From: gshaff@gmail.com
Sent: Tuesday, March 11, 2025 6:45 PM
To: Planning Commission - Public Testimony
Subject: HEARINGS PLANNING ACTION: PA-T2-2024-00053 - Variance

RE: PLANNING ACTION: PA-T2-2024-00053 – 231 Granite Avenue

To: Planning Commissioners
From: Amy Gunter, Rogue Planning & Development Services, LLC
Date: March 17, 2025
Re: PA-T2-2024-00053

DATE: March 18, 2025
TO: Planning Commission
FROM: Brandon Goldman, Community Development Director
RE: 231 Granite Street

DRAWN : CHECKED:
 TS CD
 DATE :
 03/12/25
 PROJECT :
 ROGERS_24
 SHEET :
A1.0

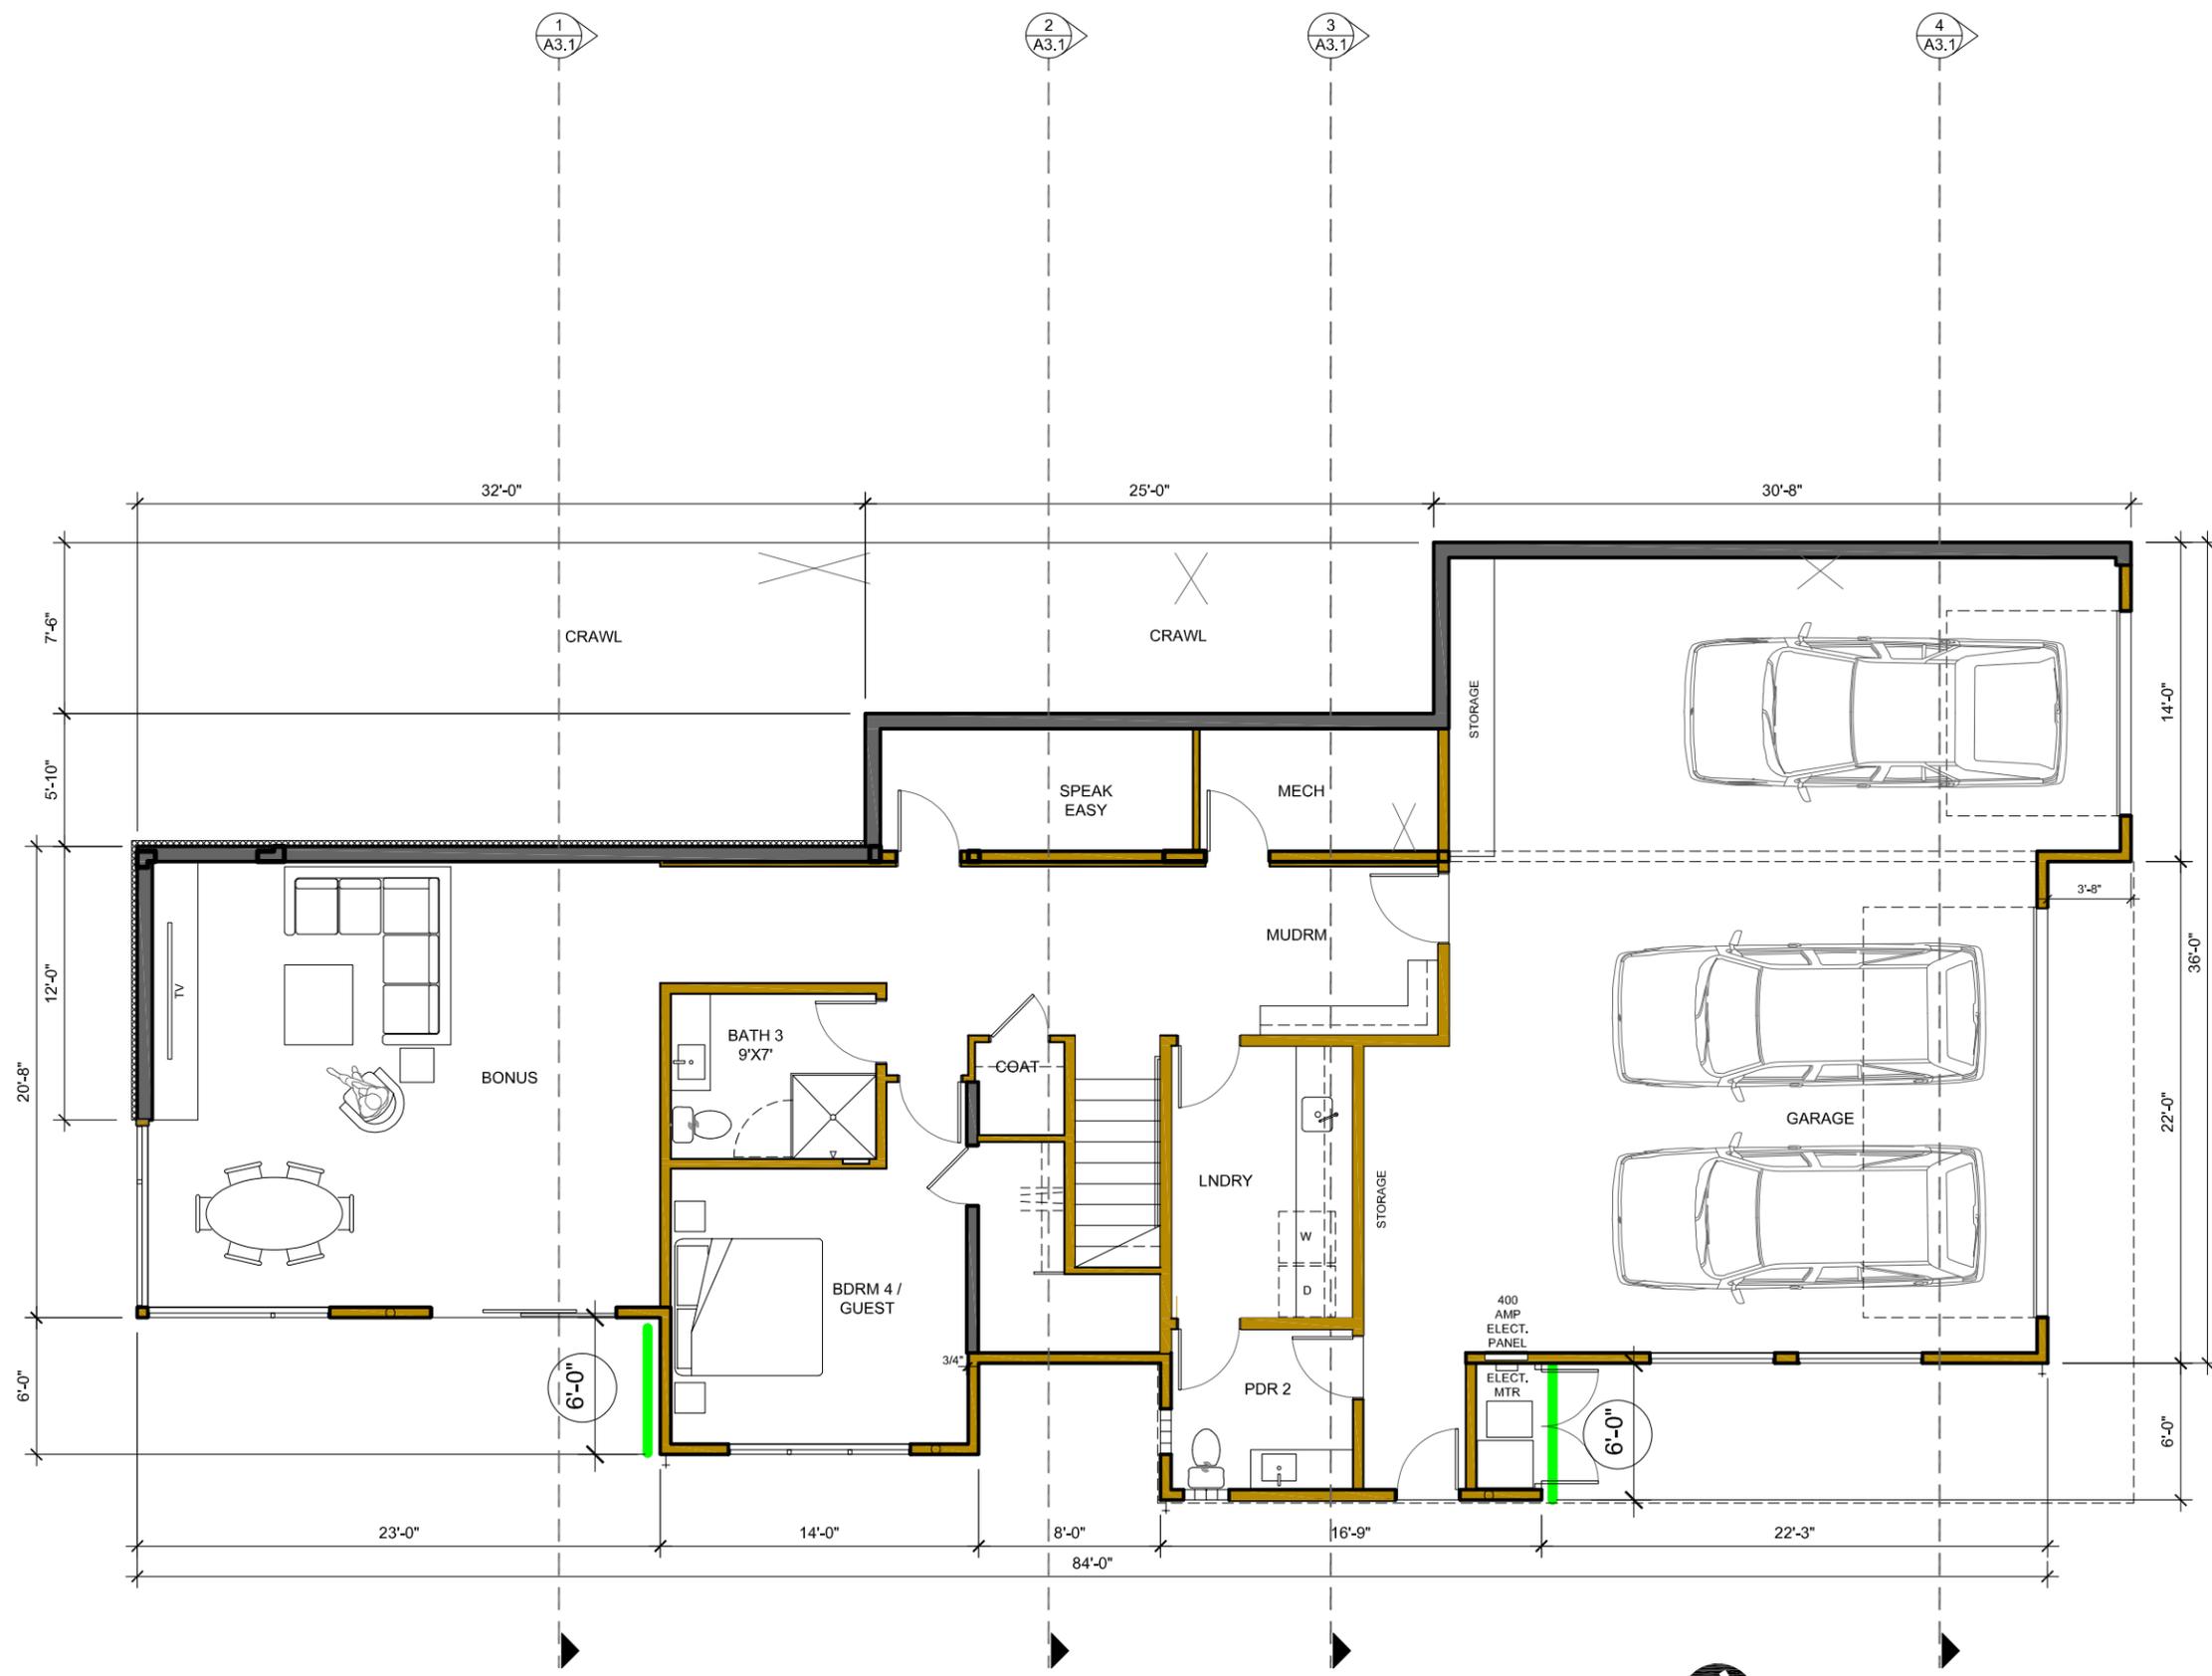
1. An Exception to Hillside Design Standard AMC 18.3.10.090.E.2.d. was requested.
18.3.10.090.E.2.d. Continuous horizontal building planes shall not exceed a maximum length of 36 feet. Planes longer than 36 feet shall include a minimum offset of six feet.

This exception has been eliminated from the east and south sides of the proposed structure through footprint and façade alterations that increase the offsets to six feet. This also reduces the floor area of the home by 44 square feet. See attached sheet A1.0., A1.1., A2.2., and A2.1.

DRAWN : CHECKED :
TS CD
DATE :
03/12/25
PROJECT :
ROGERS_24
SHEET :
A2.2

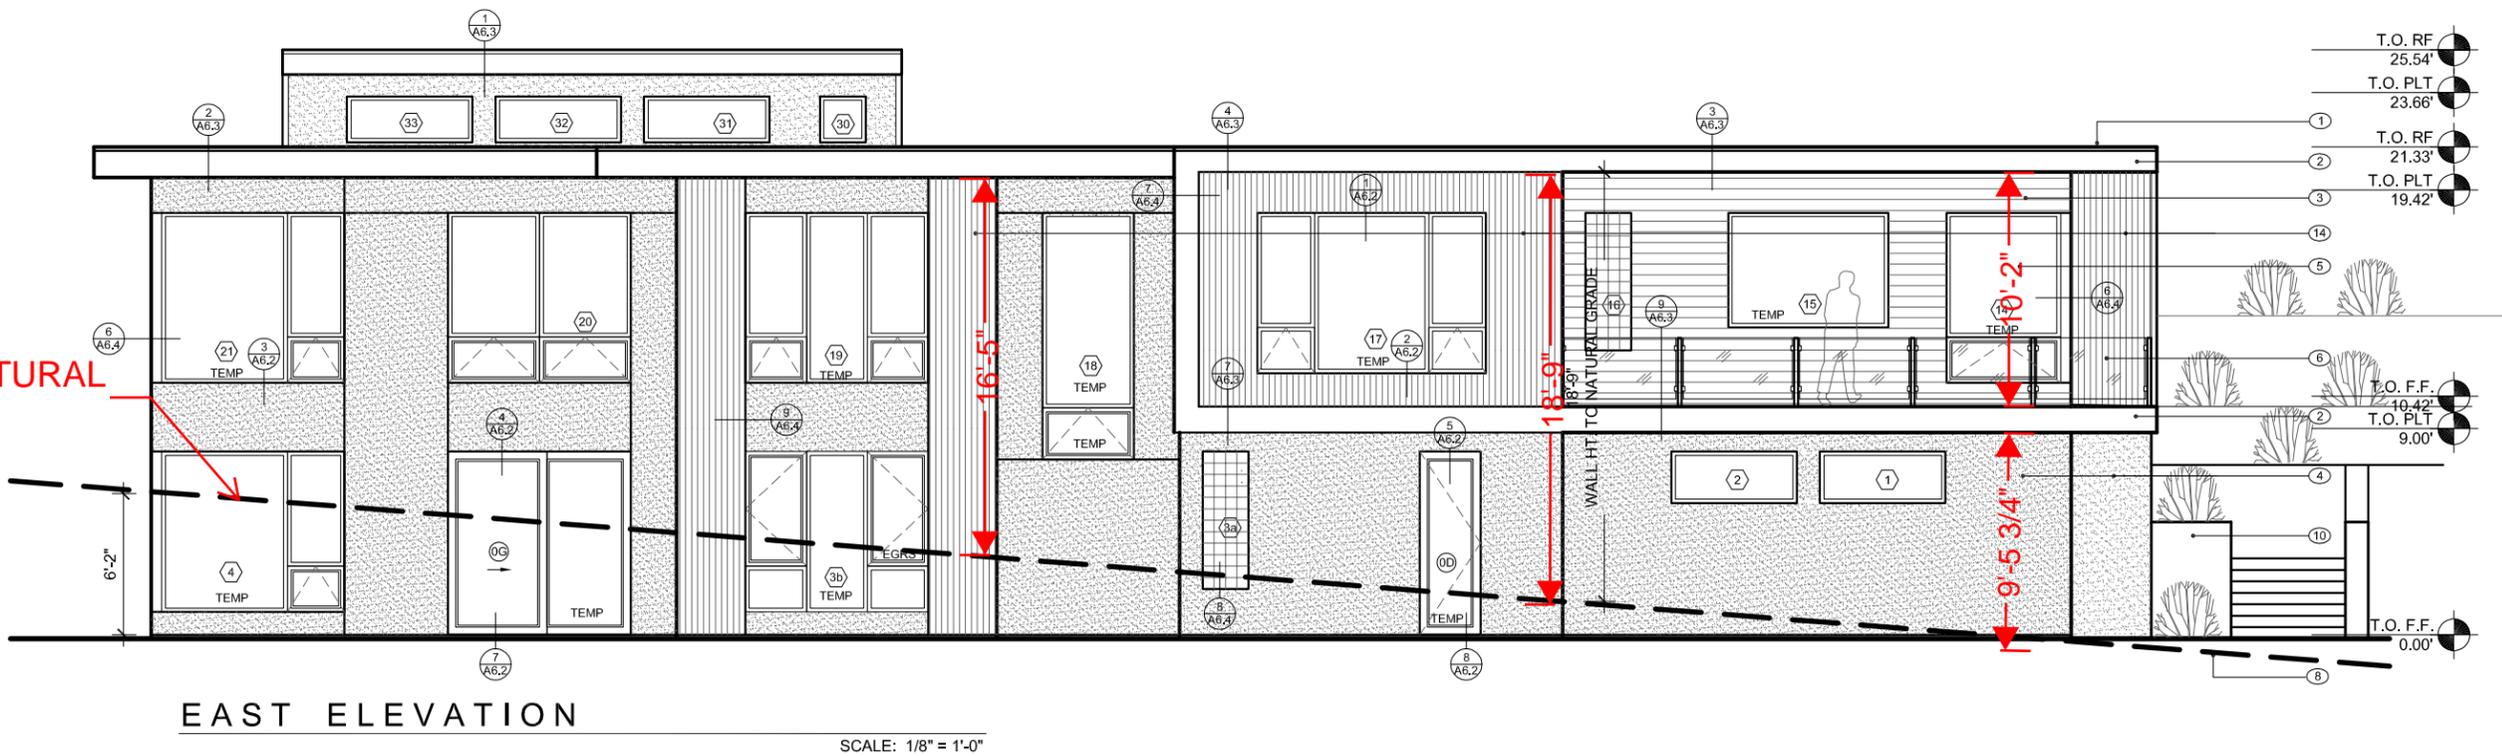
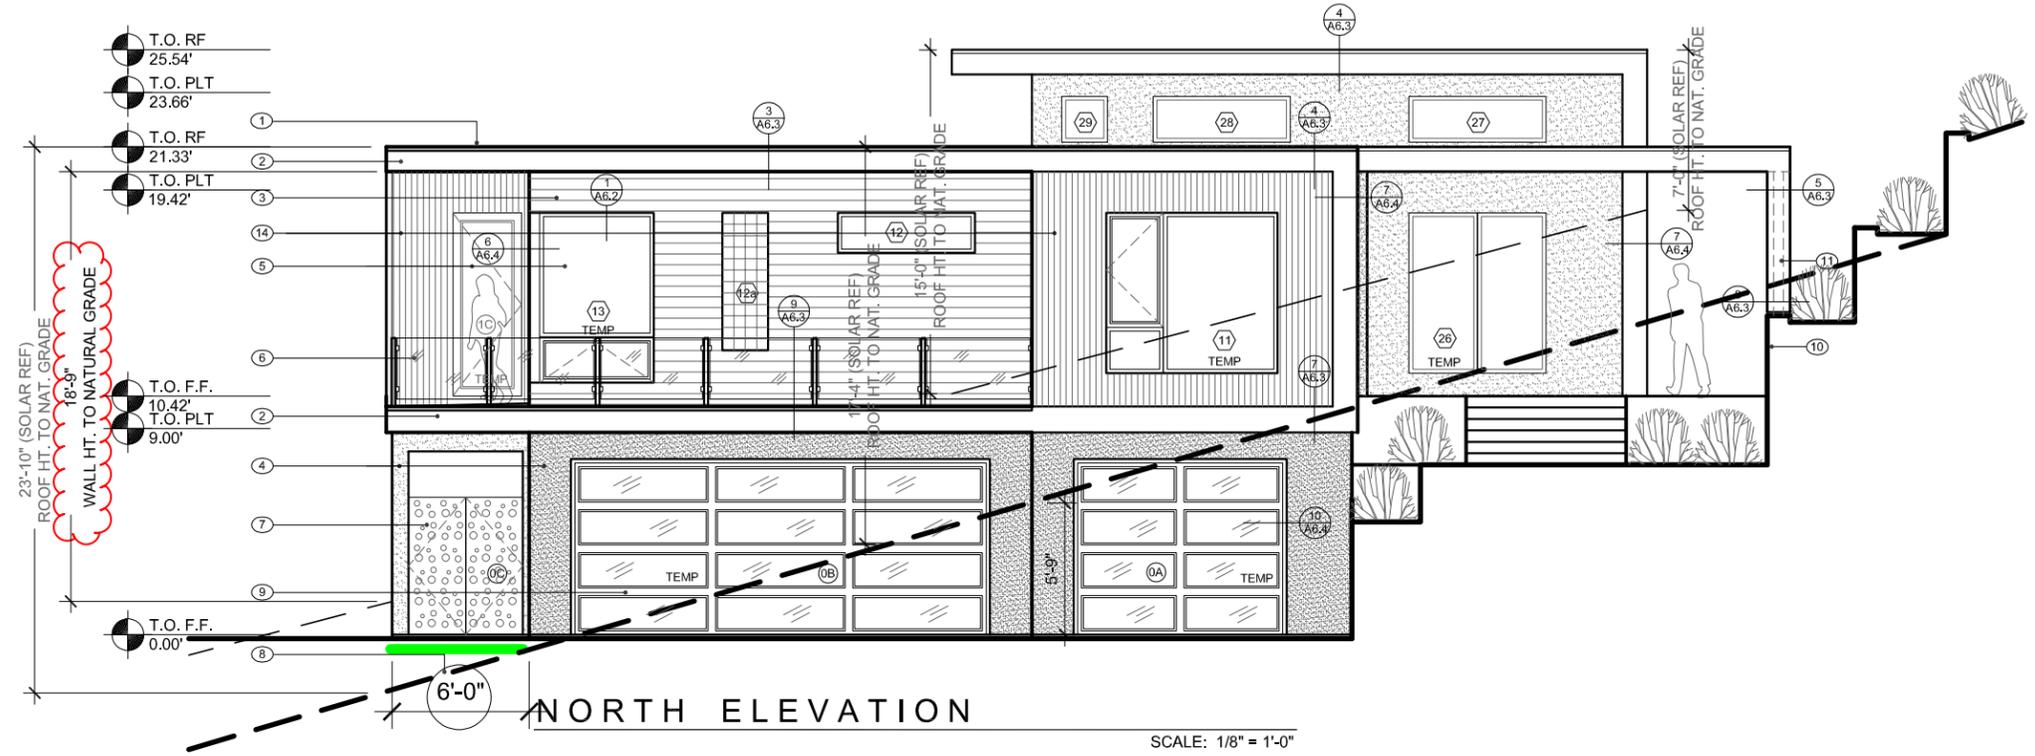
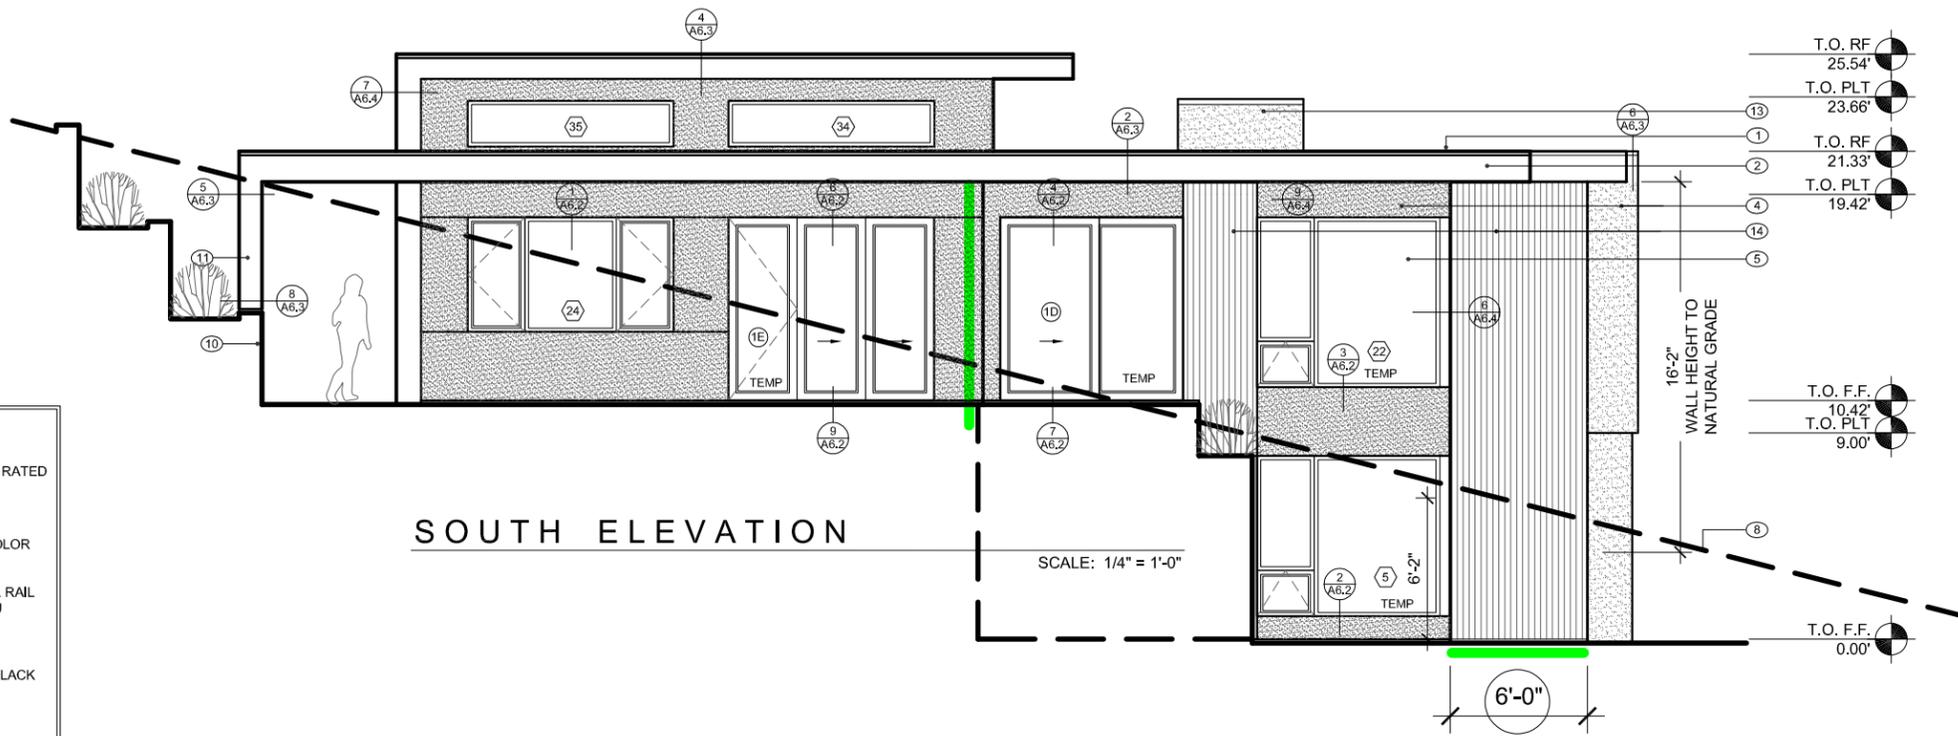
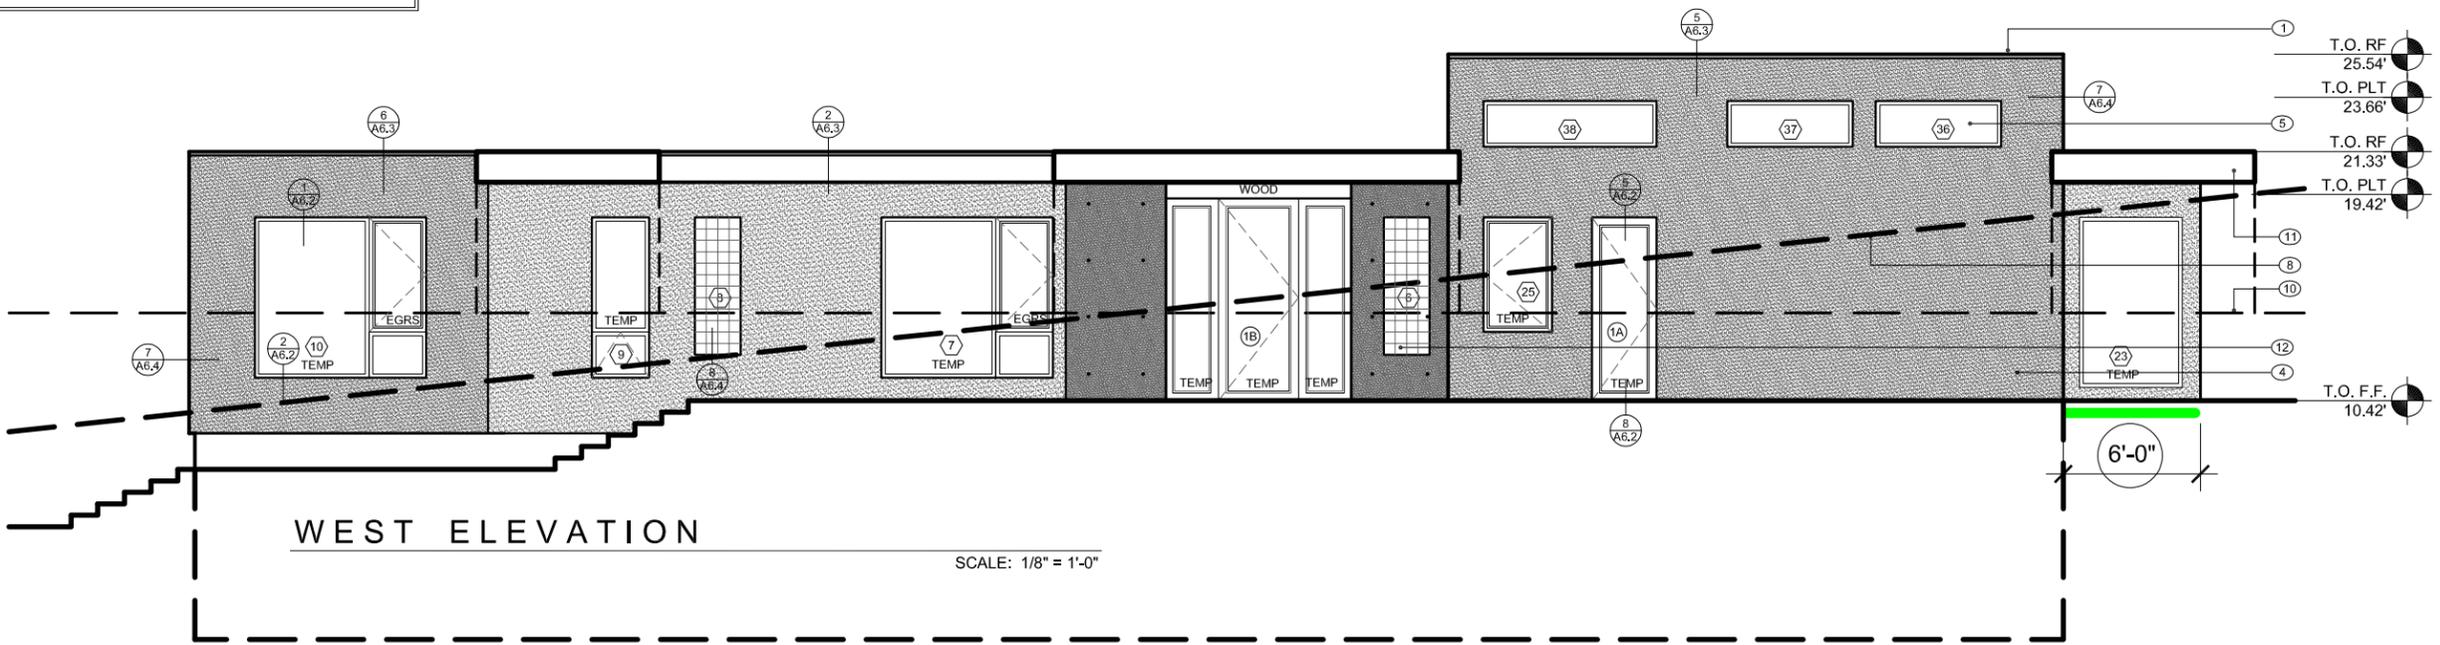
2. An Exception to Hillside Design Standard AMC 18.3.10.090.E.2.c. is not required.
18.3.10.090.E.2.c. A building step-back shall be required on all downhill building walls greater than 20 feet in height, as measured above natural grade. Step-backs shall be a minimum of six feet. Decks projecting out from the building wall and hillside shall not be considered a building step-back. No vertical walls on the downhill elevations of new buildings shall exceed a maximum height of 20 feet above natural grade. See Figure 18.3.10.090.E.2.c.

not be included in the downhill wall height measurements. This does not require an exception to the design standards. See attached sheet A2.1. and A2.2.
